The Corporation of the District of Saanich

Report

To: Mayor and Council
From: Sharon Hvozdanski, Director of Planning
Date: September 29, 2015
Subject: Development Permit Amendment
File: DPA00822 • 3934 Quadra Street

Figure 6: Section of North Elevation Adjacent to Quadra Street Entrance (Provided by CEI Architecture)

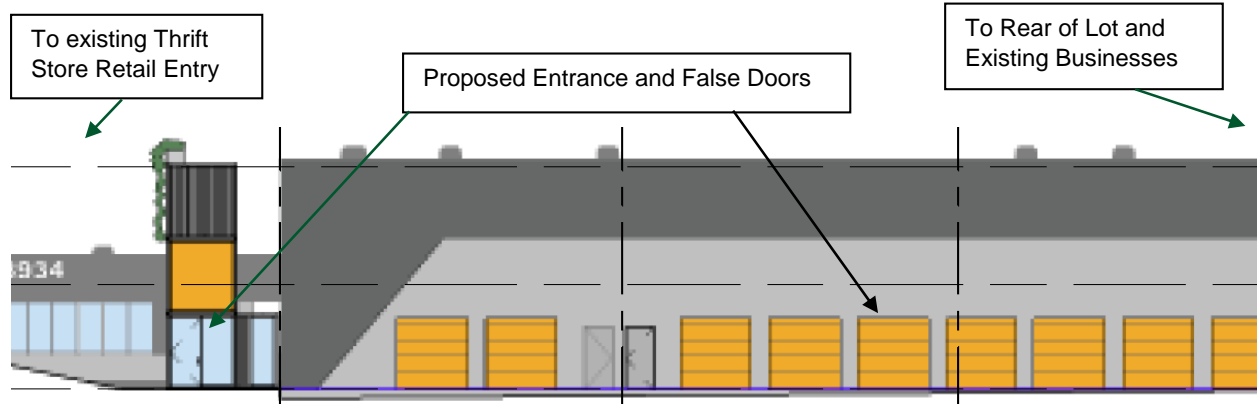
The proposal also includes exterior changes to the north elevation facing a parking area with the addition of ten surface mounted, false overhead doors as architectural features, which would also provide the benefit of reducing the impact of the existing relatively large, blank concrete wall. The proposed false doors and existing overhead doors would all be painted orange (see Figures 5 and 6). An existing colour band along the roof line would also be repainted with a darker grey colour than the existing colour on the north, east, and west elevations.

The Quadra Cedar Hill Community Association considered the application and provided the following comments. They do not support the false overhead doors proposed for the north elevation on aesthetic grounds. They also interpret the proposed false doors as signage and contend it would not meet the Sign Bylaw. They also note that the parking stalls available through the parking agreement with the adjacent property are not available in the evening, and that they would prefer to see a comprehensive redevelopment of the site.

Staff note, the false doors are not considered signs under the Sign Bylaw but rather would be considered architectural features, which would also provide the benefit of reducing the impact of the existing relatively large, blank concrete wall (see Figure 5). Although the proposal is not a comprehensive redevelopment of the site, it could be considered a transitional use that maintains a light industrial use of the property until such time that the existing building is near the end of its useful life and redevelopment of the site is something the owner wishes to pursue.
